IPC brief

# RCC Briefing of IPC SSD 9649

**Student Accommodation 4-18 Doncaster Avenue, Kensington**

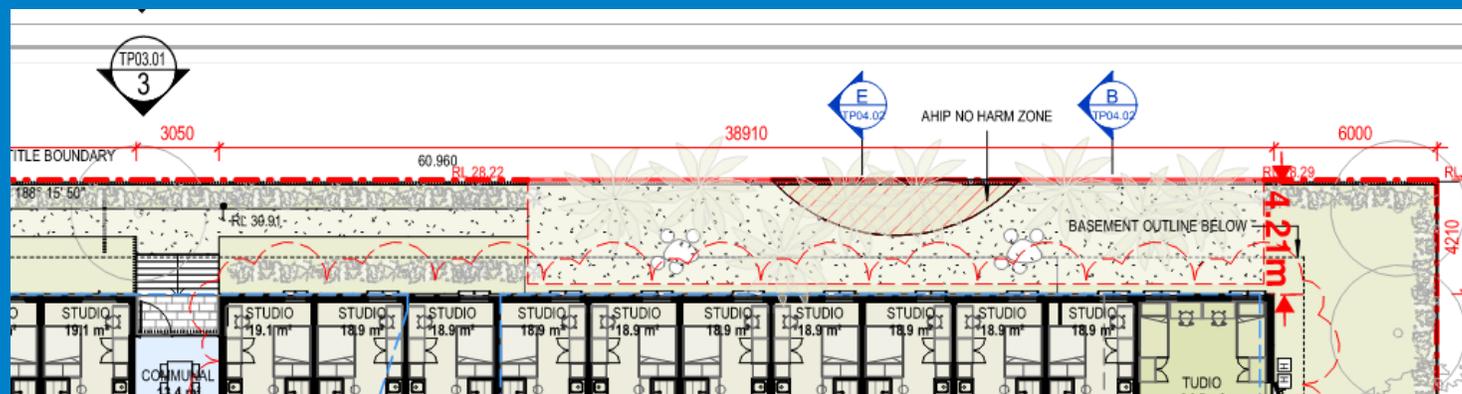
- Character test (Clause 30A of ARHSEPP):
  - Council's view is that the character for an area undergoing transition and the desired future character of an area (a key objective of the zone) is based on the outcome anticipated by the RLEP and the DCP and therefore the relevant controls within a DCP should form part of the consideration. Of particular relevance, is the 10.5m external wall height control in minimising impacts on the envisaged character of the area.

- Context: The Context of the site is that it contains a heritage item and is within the heritage conservation area. The character assessment indicates 'modern' buildings across the road assuming its referencing four storey walk-up flat buildings, which is no longer the built form anticipated or encouraged by the current planning controls.

- Compatibility of use: Council has no major concerns with the compatibility of the use, it does however it is considered that that the lack of amenity for future occupants of the building is unfortunate exhibited by - small sized rooms, lack of parking and floor area above the standard.

- Impacts on the neighbours:
    - Overshadowing: The proposed development results in greater overshadowing of the southern neighbours north facing windows.

- Visual bulk: The vertical walls exceeding the maximum 10.5m control will impact neighbours visual amenity.
    - Visual privacy: The proposed southern elevation contains angle windows with clear glazing window behind the vertical louvres and in the absence of details, how can one be sure adequate privacy can be maintained.

**3.**

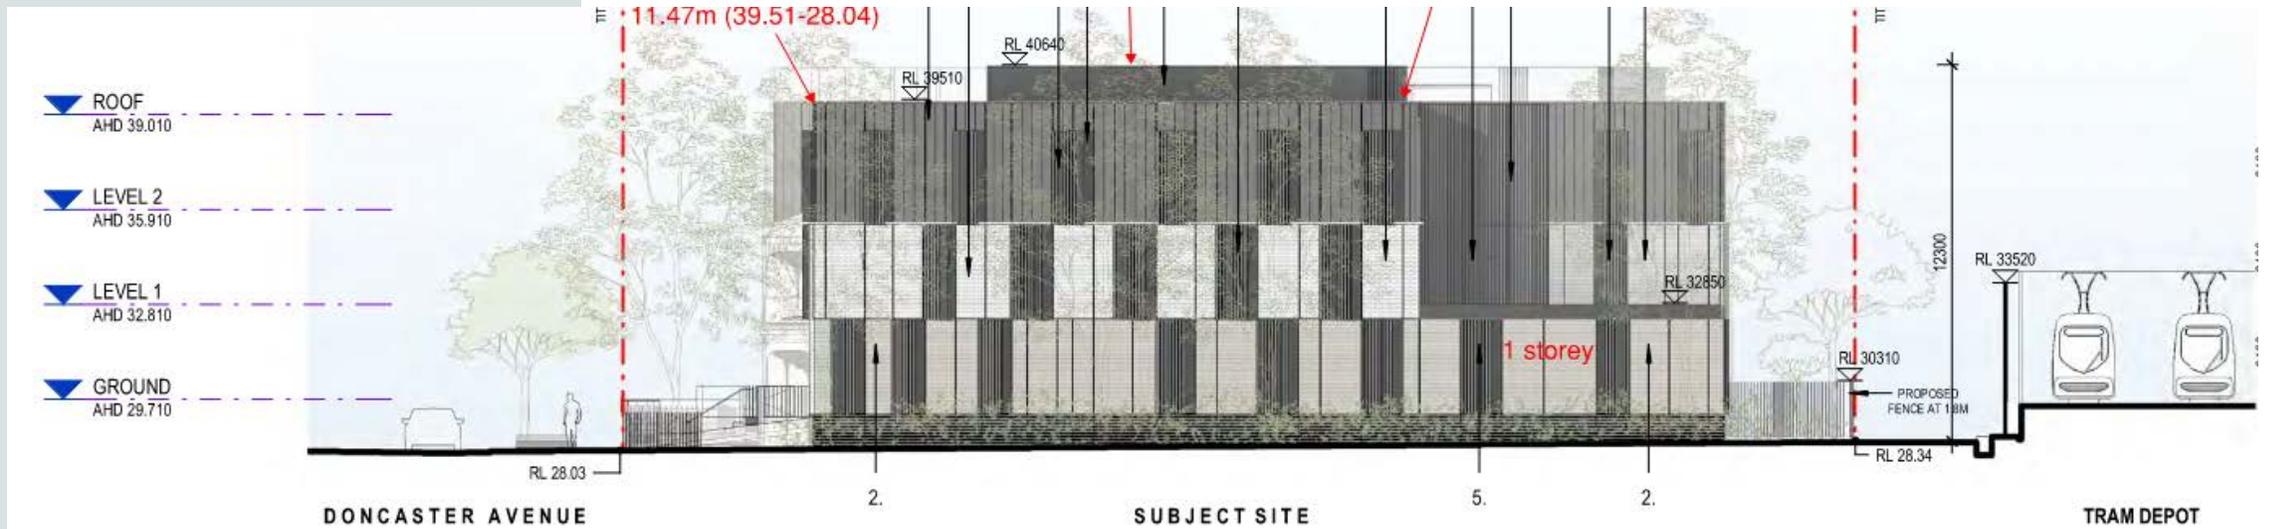
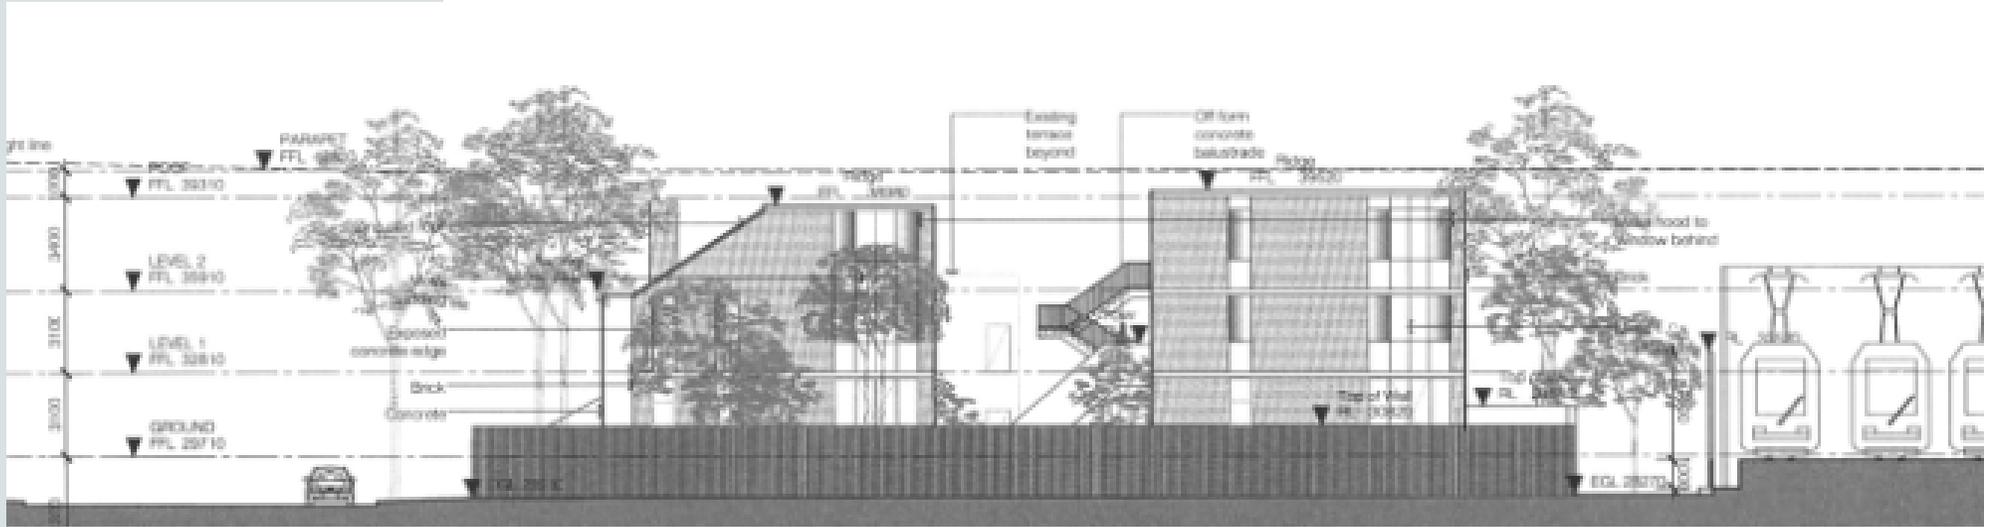
**The proposed floor levels of the new building vary between RL29.51m and 29.71m (and min 0.5m above the 1% AEP flood level). Do the new levels (and or landscaped areas levels) compromise or exacerbate flooding of the heritage buildings at RL 28.56m?**

- Insufficient modelling accompanies the application to determine whether the proposal will exacerbate flooding of the heritage item.
